CITY COUNCIL WORK SESSION AGENDA
Work Session - Buddy Attick Park Draft Master Plan

City Council Work Session Agenda Item Report

SUBJECT: City Council Work Session - Draft Buddy Attick Park Masterplan

ADVISORY PLANNING BOARD**REPORT NO. 2024-04****REPORT TO COUNCIL****Date: 10/02/2024****SUBJECT: Review of Buddy Attick Park Draft Master Plan****BACKGROUND**

FIGURE 7 Site map showing existing program and features at Buddy Attick Park.

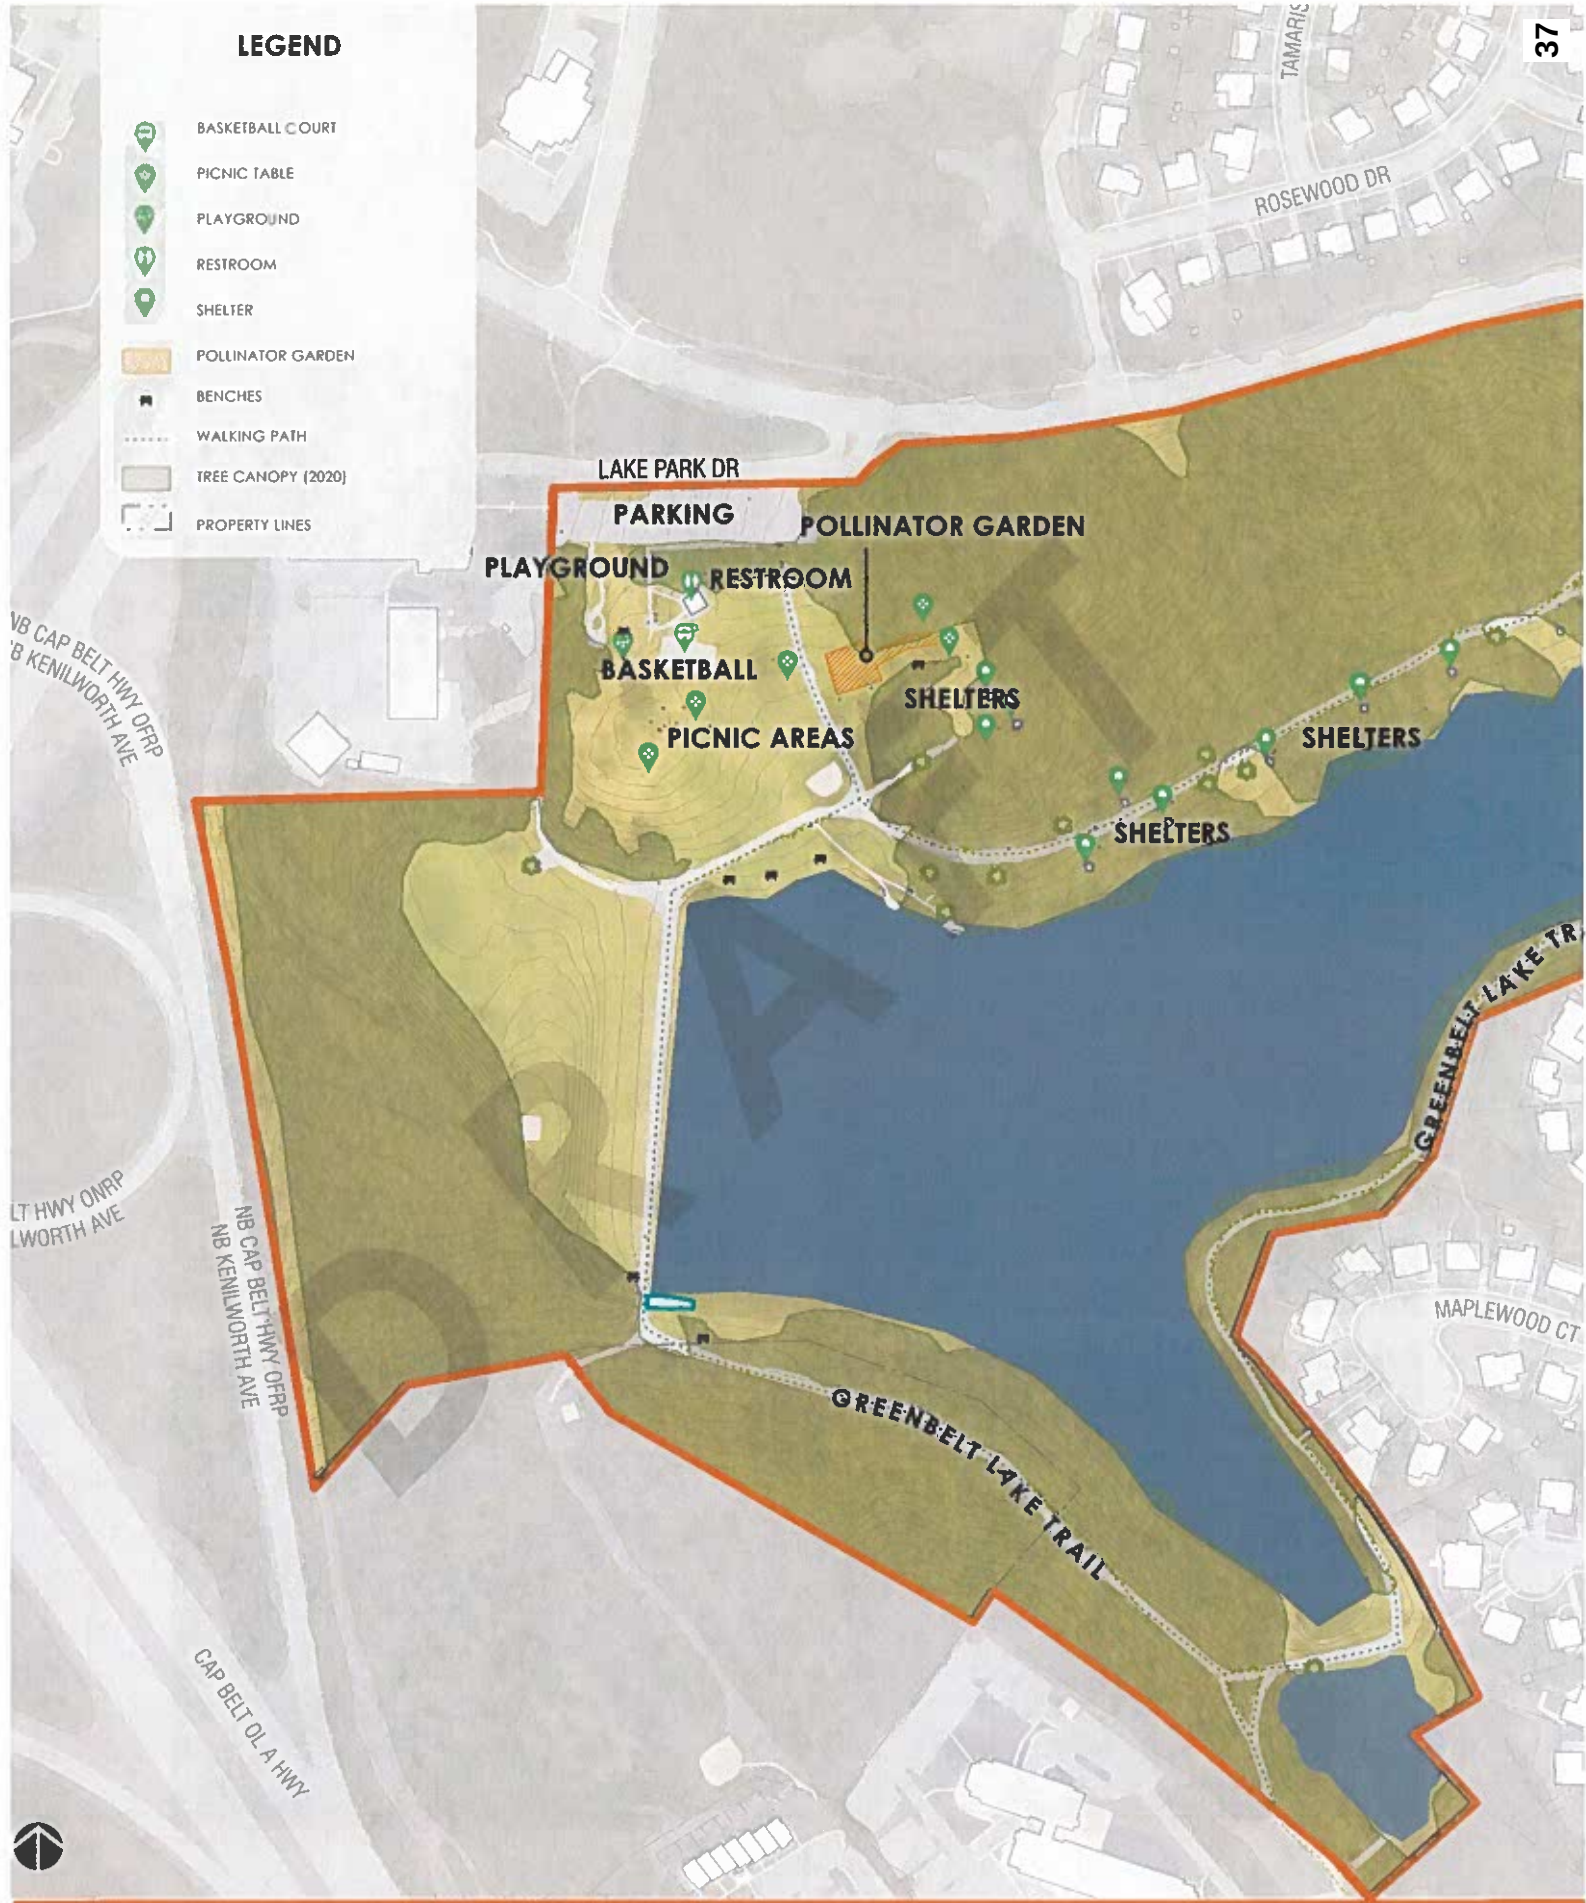
P.32 The pair of submerged aerating pumps that are currently deployed in the lake, and their power source from the lakeshore, are not mentioned or shown on the drawing of existing conditions. The plan for maintaining (or removing) this equipment should be included in the report.

FIGURE 20 South Cove Improvements at Buddy Attick Park.

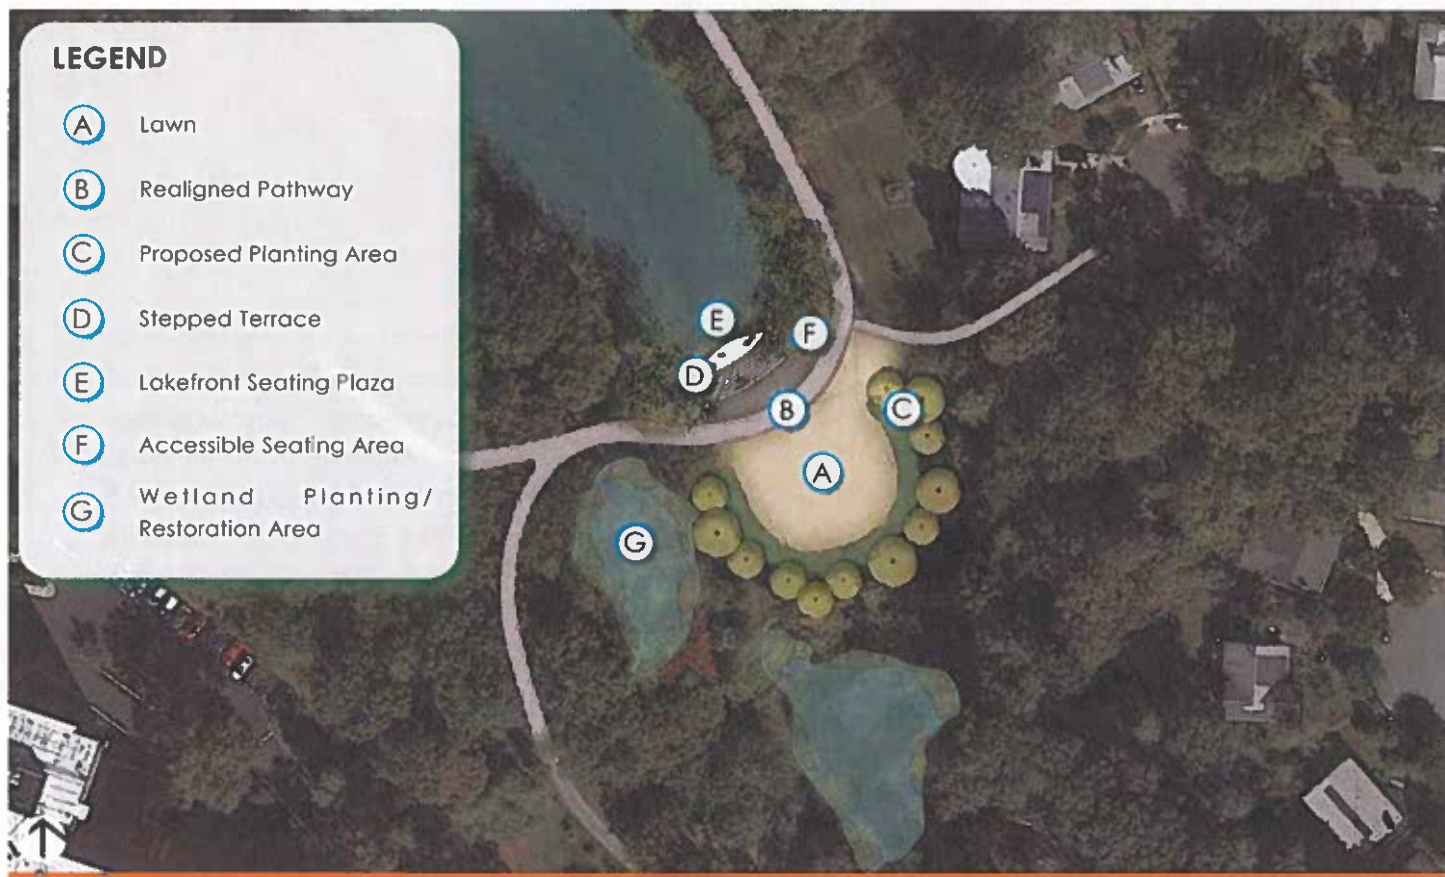
p. 45, Figure 20: Here is an opportunity to add native trees and understory to provide shade and cooling along the path to help keep the park accessible during our increasingly hot summers. I believe this is a vital accessibility issue that we should address proactively because the very young, older people, and people with various health issues can be deeply affected by high temperatures and glaring sunshine. Providing shade along as much of the path as possible will make the park a healthy retreat for everyone and not just the healthiest and most physically robust. However, I understand that shading this portion of the path may not be desirable due to the historical use of the lawn area for viewing fireworks. In that case, we must prioritize maintaining or increasing shading of the path in other areas around the lake for climate resilience and maximizing accessibility.

FIGURE 21 Peninsula Improvements at Buddy Attick Park.

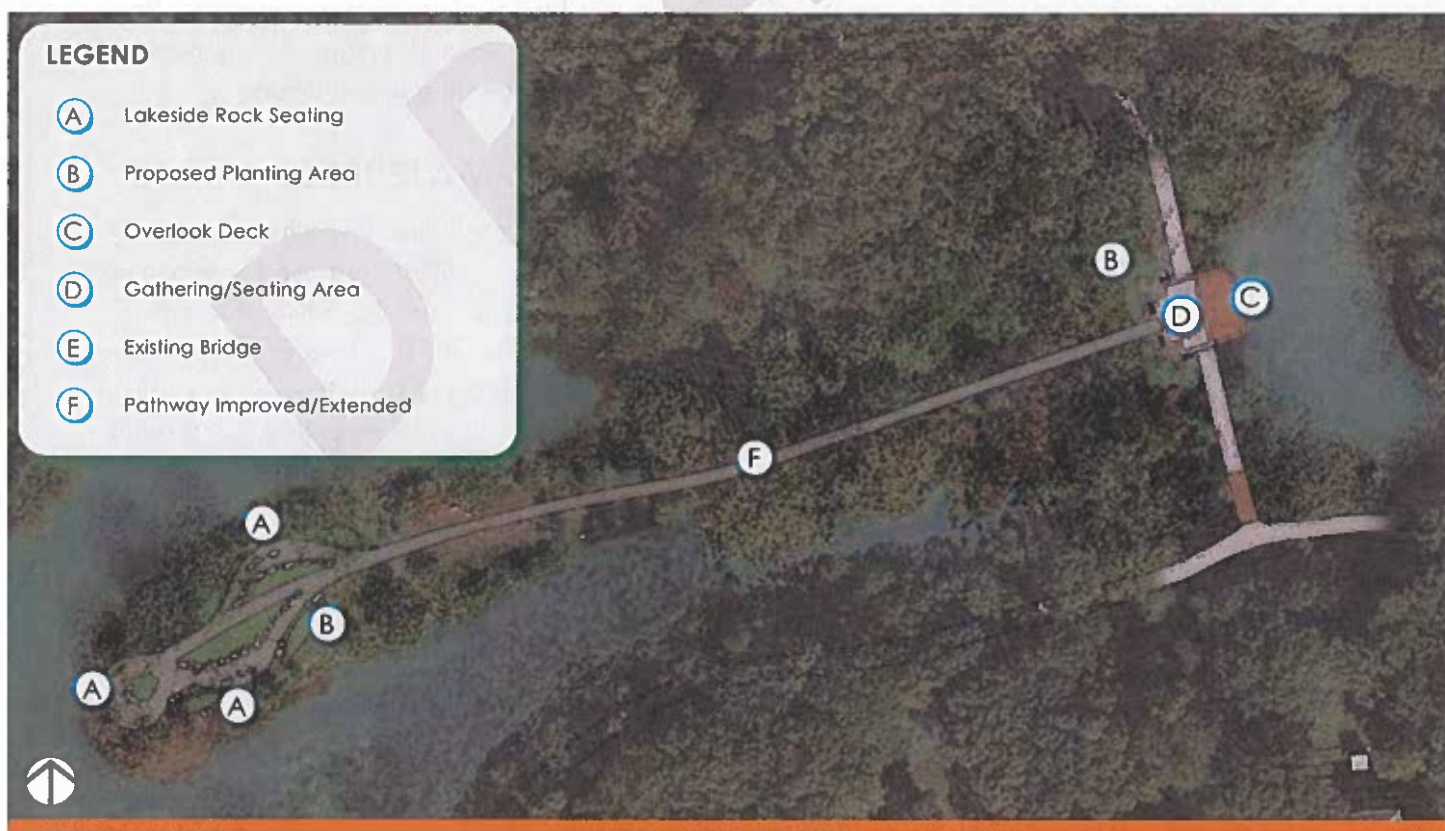
- Figure 21 should be labeled “E. Existing Bridge”.
- The Board extensively discussed the logic of the “C. Overlook Deck” and feels that the rationale for this amenity was not clear, particularly in this area where fishing should be discouraged (in particular, the illegal capture of turtles). APB suggests the contractor consider modifying the formalized entry zone by changing the location of the fence/railing to create an overlook area off the path that allows people to observe the forebay area without building a new structure that extends into the forebay, and maintains a clear separation from wildlife.

p. 45, Figure 21: Although the suggested path design for the peninsula is visually compelling, I'd prefer one that would minimize soil disturbance, increase ecological value, and provide for a more nature-centered experience. A path with spurs to each sitting area would allow for the planting of various pockets of native understory trees, shrubs, and herbaceous perennials.

Page 45. Figure 21. Missing letter E on image to denote the existing bridge.

FIGURE 22 Proposed pathway materials at Buddy Attick Park.

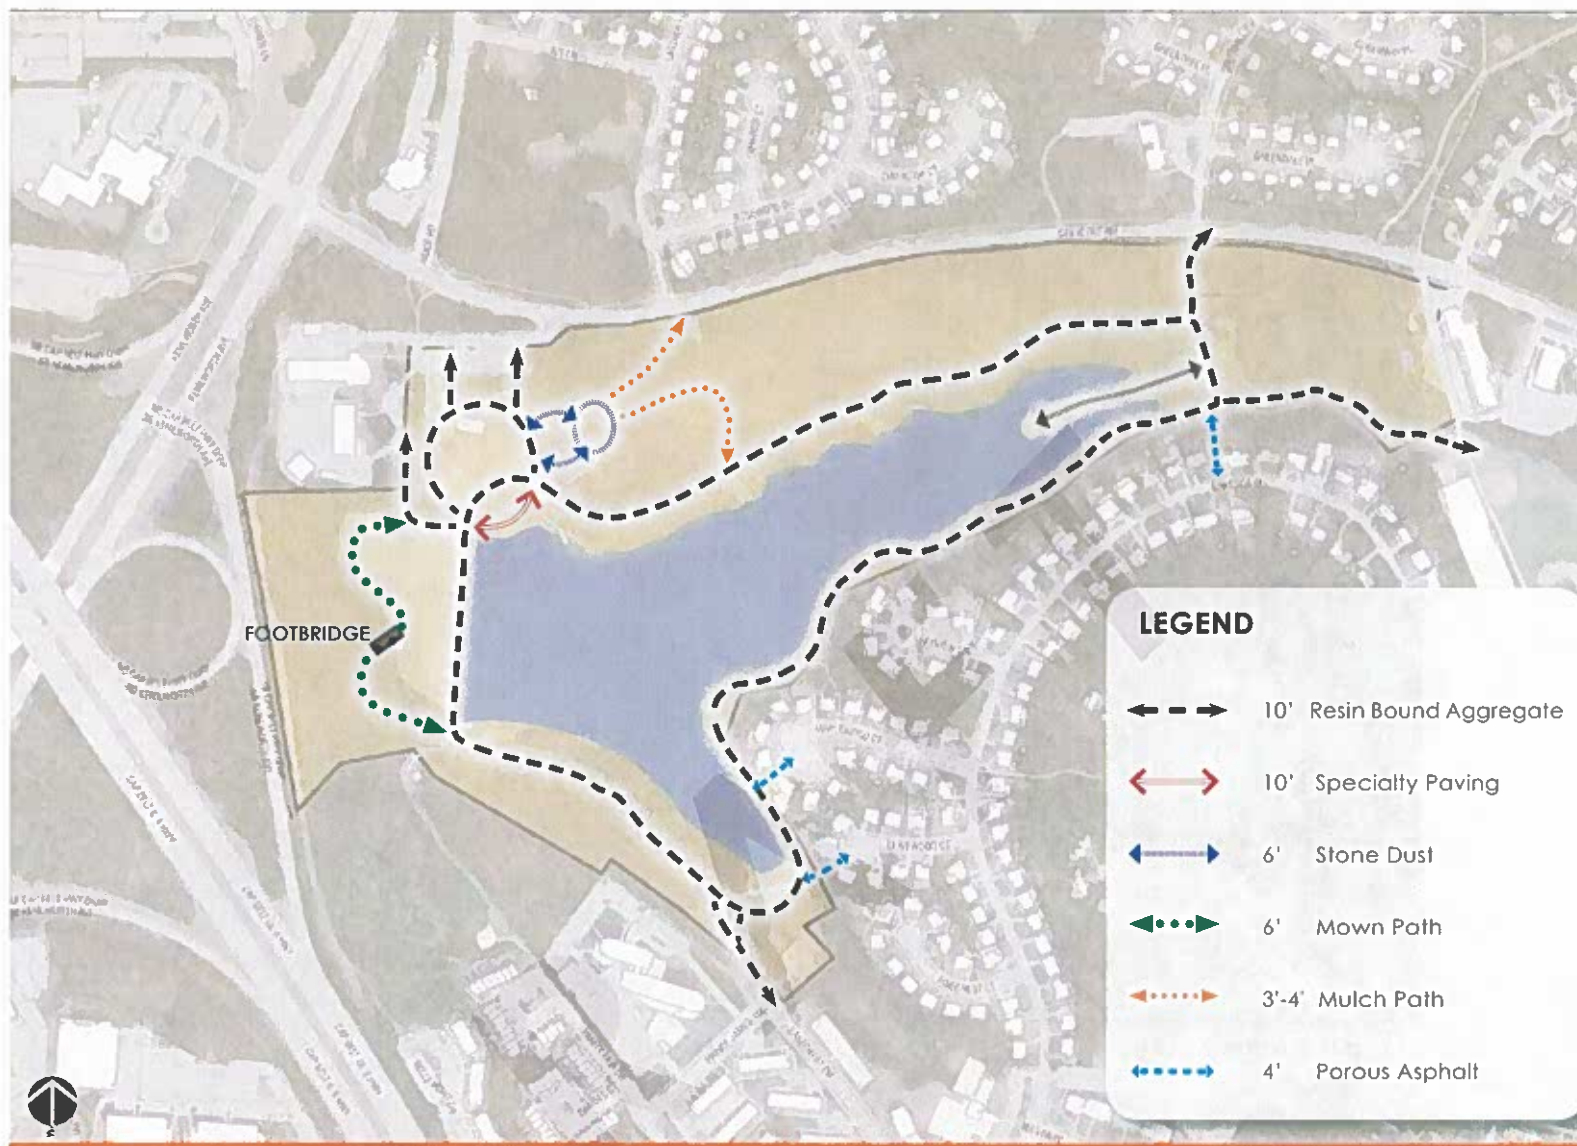
The plan needs more “green stormwater” infrastructure. Paving the path? A number of people had a lot of concern about how permeable the path would be. It is a resin gravel paving. A border is mentioned, but what will that be? The path must also provide accessibility for people with disabilities.

P.46 Concur that the lake trail should be limited to 10-ft width, no wider; in places it should be leveled to limit lateral slope. Question whether a resin-bound paving system is the best choice; specifically, is this a permeable material and if not, how will that affect stormwater runoff? Also, how does the cost of this system compare with compacted gravel, and what is the durability and longevity? Can repairs, when needed, be done by DPW staff, or must the City employ a specialty contractor to maintain the trail surface?
